STEVEN YOUNG & ASSOCIATES LTD

69 WAIONE STREET, PETONE – 6 BUILDING COMPLEX

SYAL Summary of Spencer Holmes'

Detailed Seismic Assessment

Proposed roof strengthening plan of building #1 – 69 Waione Street

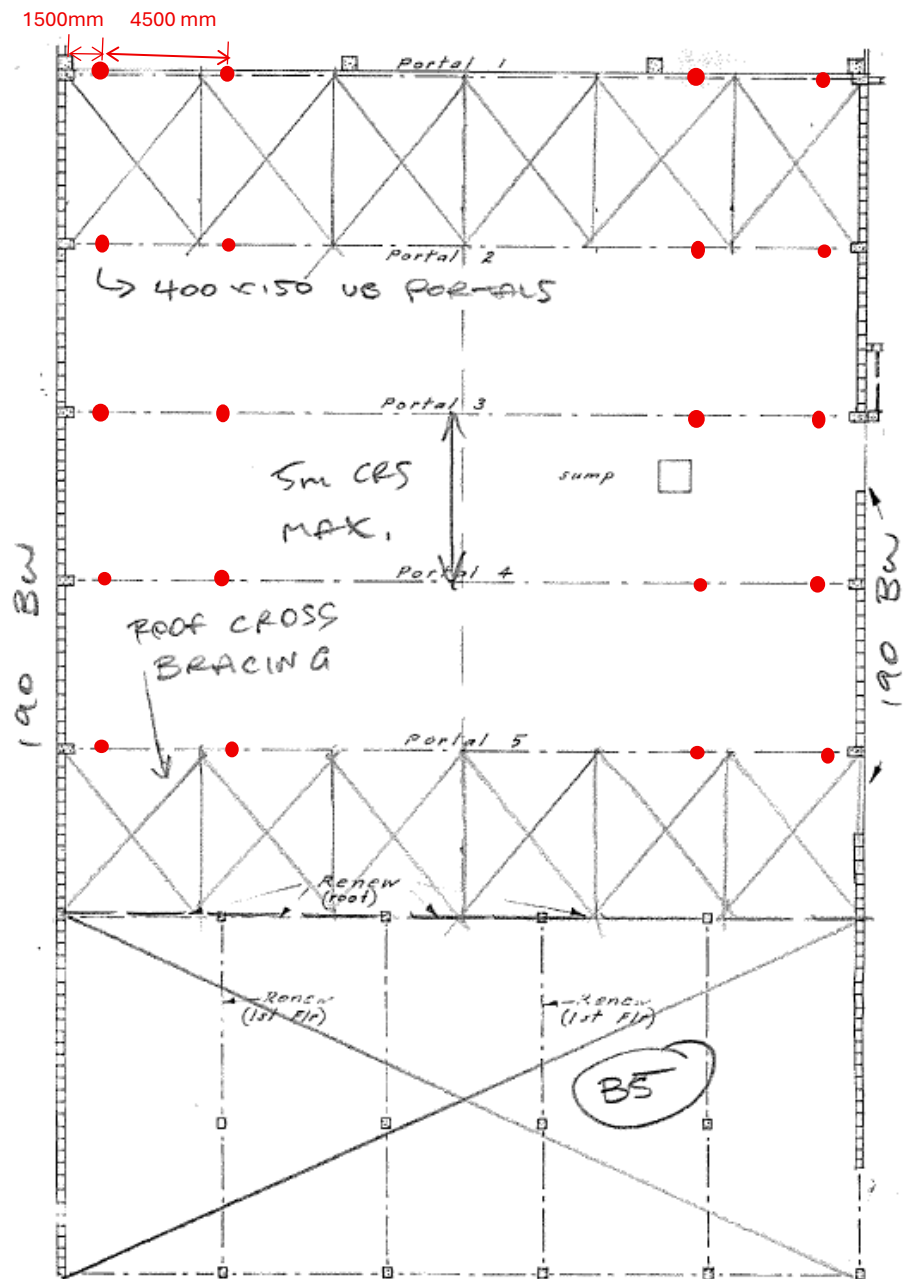
BUILDING 1	SPENCER HOLMES ASSUMPTIONS	SYAL ADJUSTMENTS	REMEDIAL WORK	REMEDIED NBS	FINAL STATUS
BUILDING 1	50%NBS, which is limited by the rating in longitudinal direction. The assessment used a ductility of 1 and assumed a pin base for portal frames.	Ductility could be at least 1.5 because the columns of portal frames are steel encased. In addition, the bases of the portal columns have some fixities because of the presence of the hold-downs and the axial load. We also identified a need for providing more fly-braces.	Fly braces added	70%NBS	Not EQ Risk
BUILDING 2	40%NBS. The assessment assumed that the block panels span one-way vertically, leading to an overestimated loading action (the truth is the block panels span two ways) by 32%. In addition, the top beams are continuous at column supports but the moment demand was calculated using a simply beam assumption, leading to an increased moment action by 50%.	As such, we adjusted the moment demand of the top beam and the adjusted moment action is about 50% of SH's value. As such, we concluded a rating of over 70%NBS. We also identified a need for providing more fly-braces.	Fly braces added	70%NBS	Not EQ Risk

Proposed roof strengthening plan of building #2 – 69 Waione Street

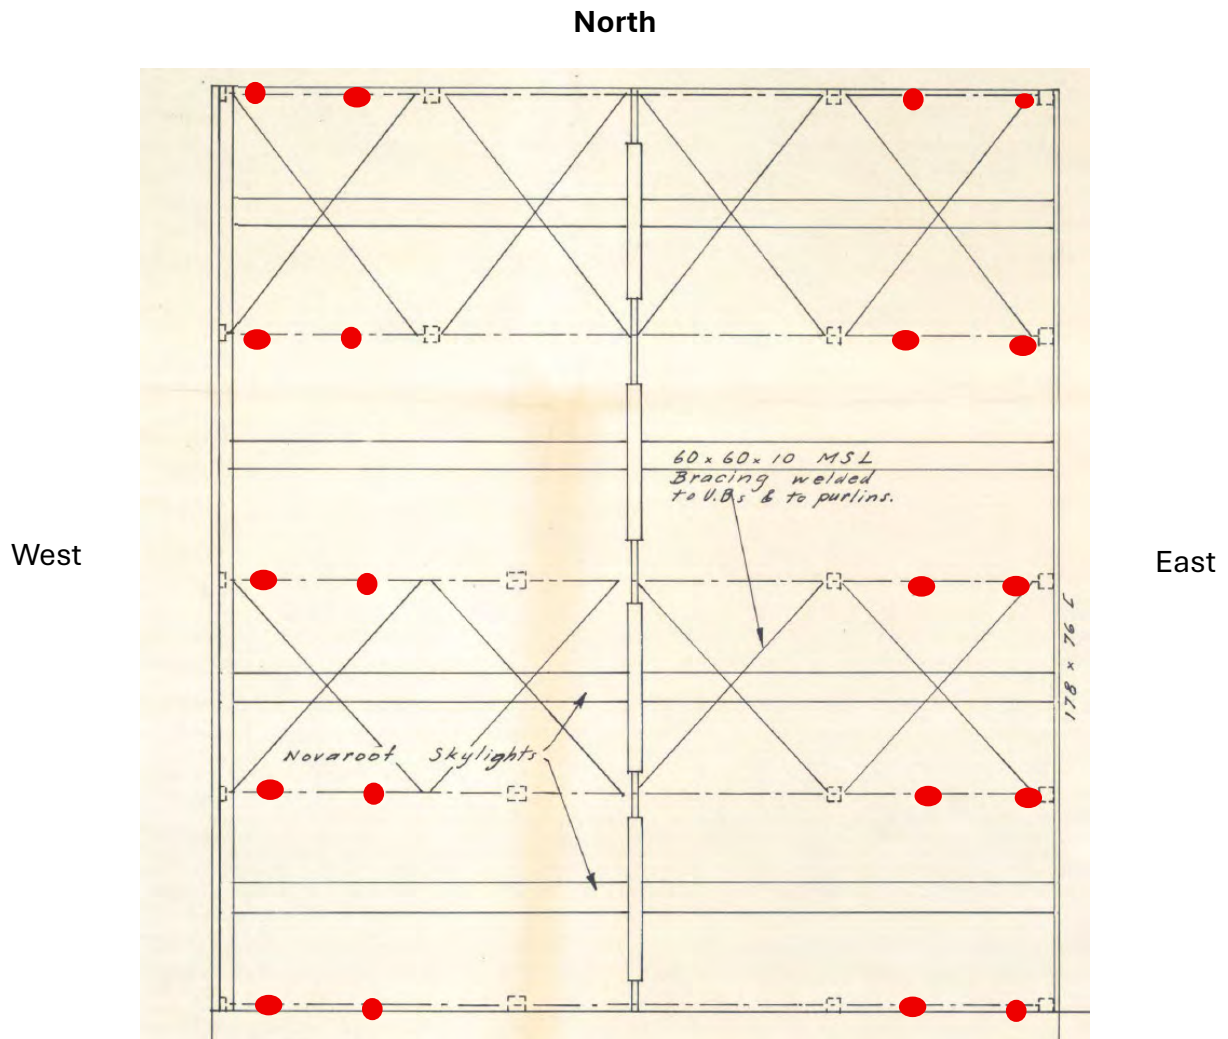
Note: 1.5 from the knee joint and 6m from the knee joints

Proposed roof strengthening plan of building #3 – 69 Waione Street

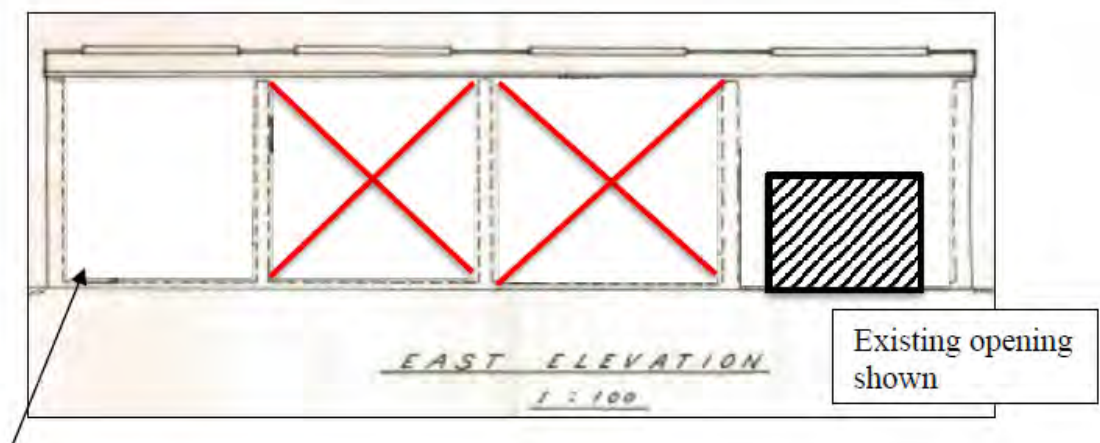
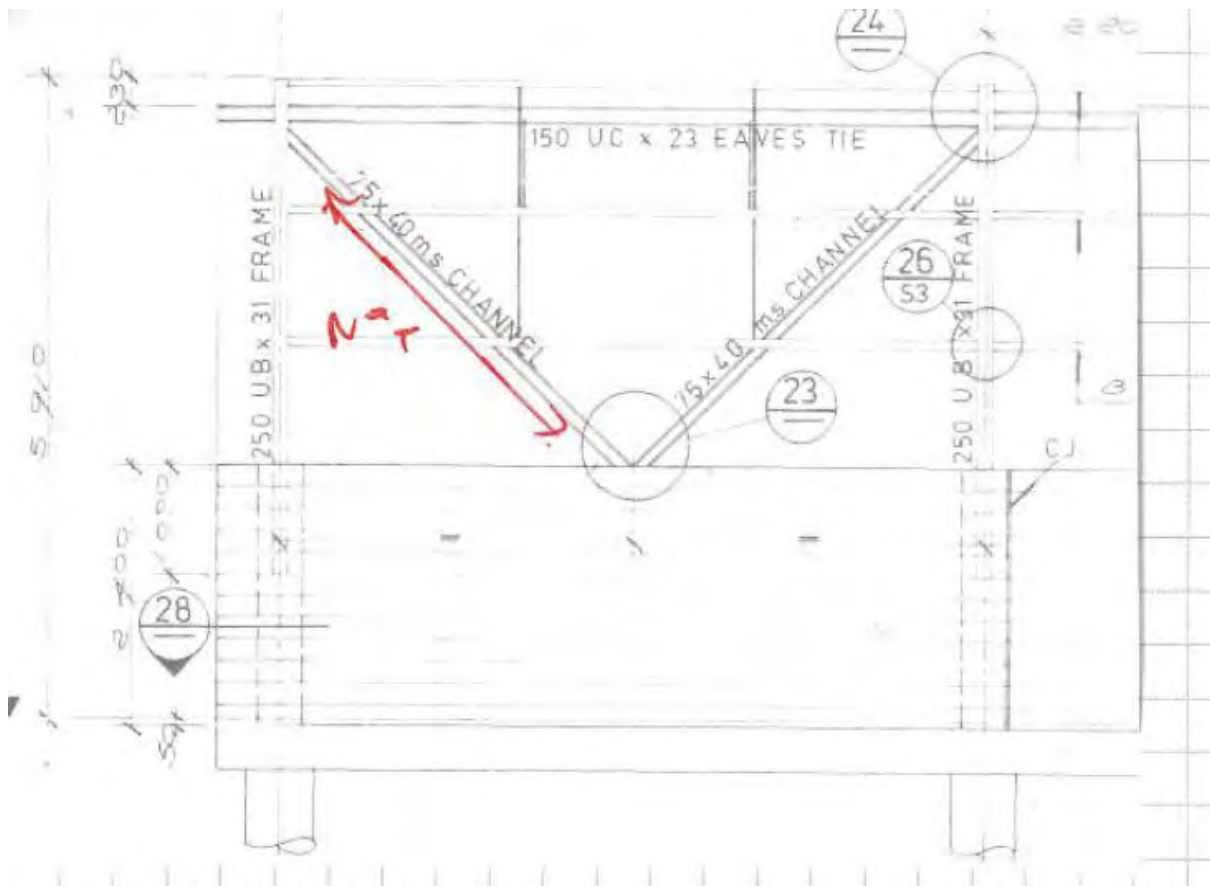
BUILDING 3	30%NBS. The assessment identified a critical issue - the lack of bracing systems in eastern wall.	SYAL also identified that there are not adequate fly-braces to portal rafters. As such, it is suggested that fly-braces be added to portal rafters and cross braces be added to the eastern wall.	Cross braced frames are added to the eastern wall. Fly-braces are added.	70%NBS	Not EQ Risk
BUILDING 4	60%NBS. The assessment did not reduce the live load based on the floor area, leading to significantly overestimated seismic mass.	As such, we adjusted the seismic mass (by about 50%). It is recommended that the V brace connection to block infills be strengthened and more fly-braces be added to portal rafters, similar to building #1.	Fly braces added. V brace connection to block infills be strengthened.	70%NBS	Not EQ Risk
BUILDING 5	30%NBS. The assessment made a calculation error in calculating the seismic mass, leading to significantly overestimated seismic mass.	As such, we adjusted the seismic mass (by about 50%). It is recommended that roof braces be added.	Roof braces added.	70%NBS	Not EQ Risk

— Braces are 60x60x10EA

East wall elevation showing the proposed strengthening using cross braces

Proposed retrofit for building #4 of 69 Waione Street

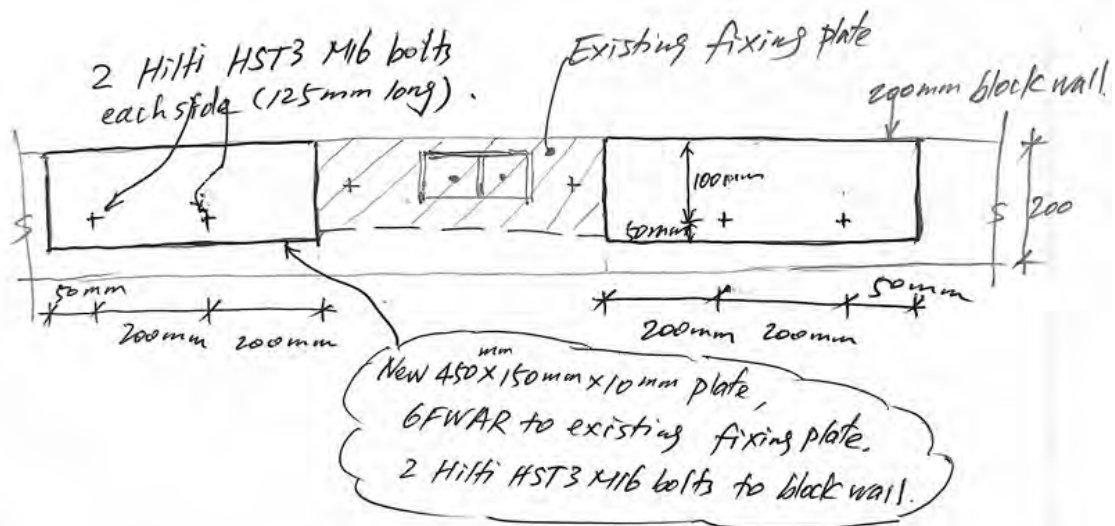
Note: Add the missing fly-braces (Add one fly brace 1.5 meter from the knee on each side of the roof rafter)

Existing elevation showing the details from V braces to block wall (In totally, 4 sets)

Plan showing the proposed retrofit of the fixing details from V braces to block wall
